SERVICE CHANGE

1.Change on Motor and Housing.

## SERVICE CHANGE

2. Change on Slider, Shoe, and Housing from S/N 599231E for 4390D, and S/N 41916E for 4390DW.

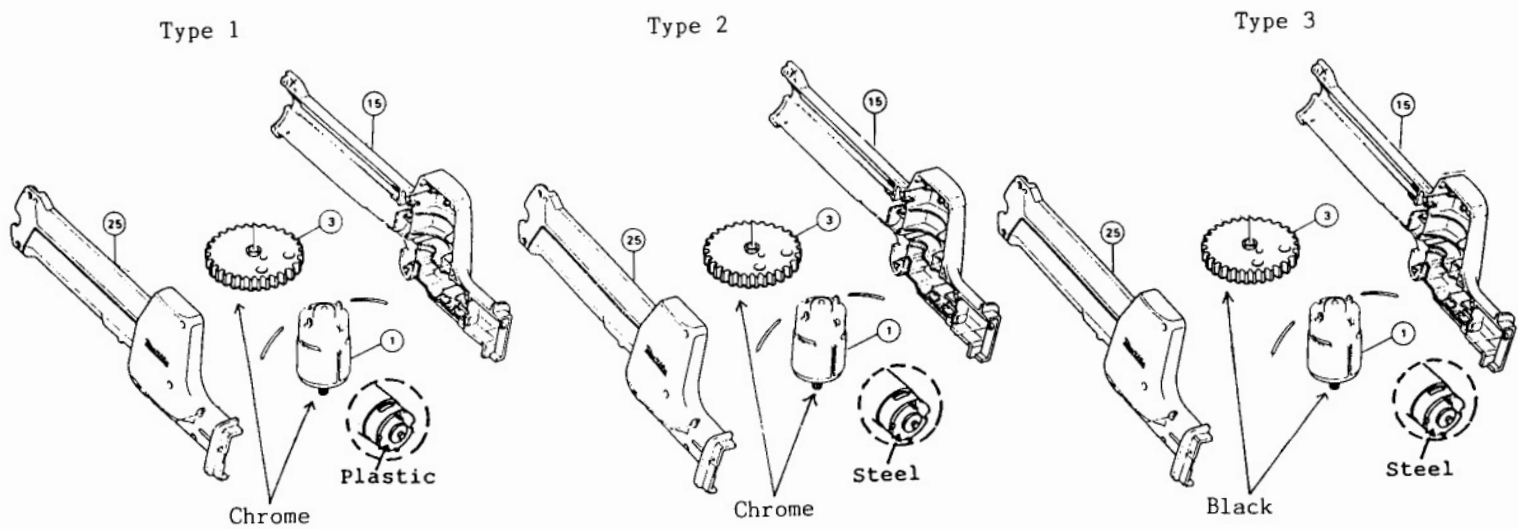
| Fig.     | Description | Type 1                           | Type 2                                        | Type 3                                      |
|----------|-------------|----------------------------------|-----------------------------------------------|---------------------------------------------|
| 1        | Motor       | Part #629544-7<br>(Discontinued) | Part #629578-0<br>(Discontinued)              | Part #629581-1<br>w/ Pinion Gear (221882-9) |
| 3        | Gear        | Part #153157-7<br>(Discontinued) |                                               | Part #153202-8                              |
| 15<br>25 | Housing Set | Part #181971-1<br>(Discontinued) | Part #182136-8<br><b>SEE SERVICE CHANGE 2</b> |                                             |

The above parts are completely interchangeable as a set.

SERVICE NOTE

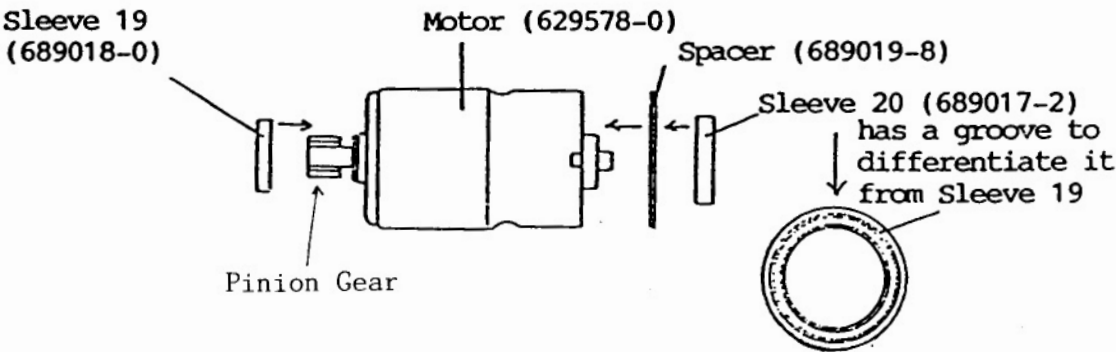
1. Type 2 Motor fits Type 1 Housing when below parts are added.

2. Type 2 Motor can be used with Type 3 Gear by replacing Pinion Gear on Motor (Part #221920-7) to Type 3 Motor's Pinion Gear (Part #221882-9).

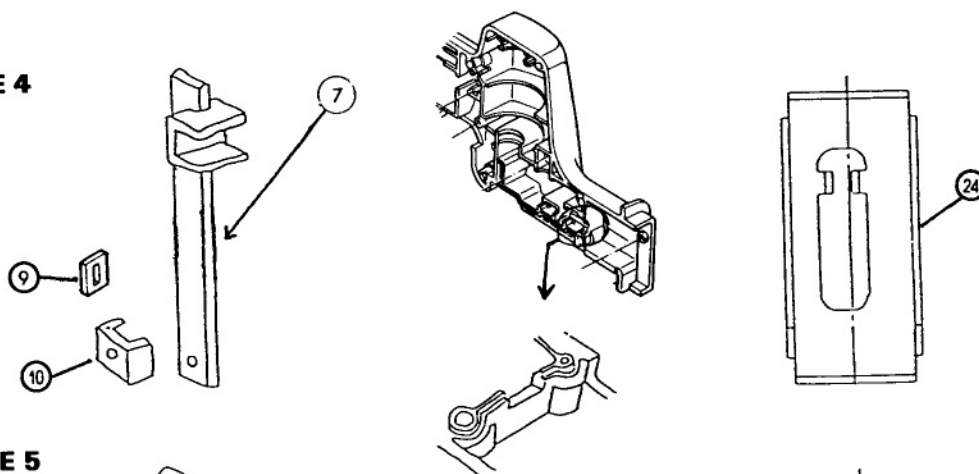
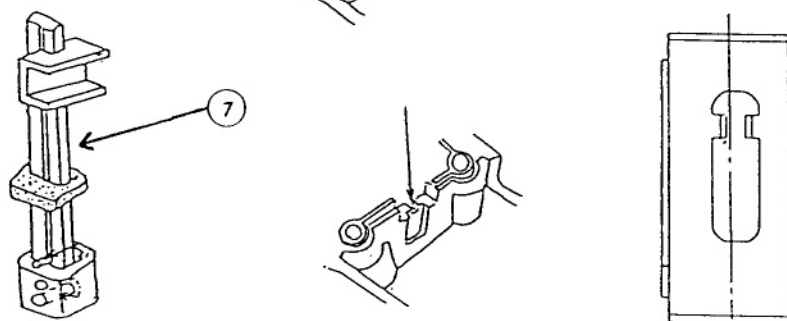
| FIG.     | DESCRIPTION | TYPE 4                           | TYPE 5                                        |
|----------|-------------|----------------------------------|-----------------------------------------------|
| 9        | Felt        | Part #443063-7                   | -----                                         |
| 10       | Blade Set   | Part #331211-9                   | -----                                         |
| 7        | Slider      | Part #164774-8                   | Part #154401-5<br>(w/blade clamp<br>313057-5) |
| 15<br>25 | Housing Set | Part #182136-8<br>(Discontinued) | Part #182406-5                                |
| 24       | Shoe        | Part #343456-7<br>(Discontinued) | Part #343875-7                                |

The above parts are interchangeable as a set, except Type 5 housing replaces Type 4 housing individually.
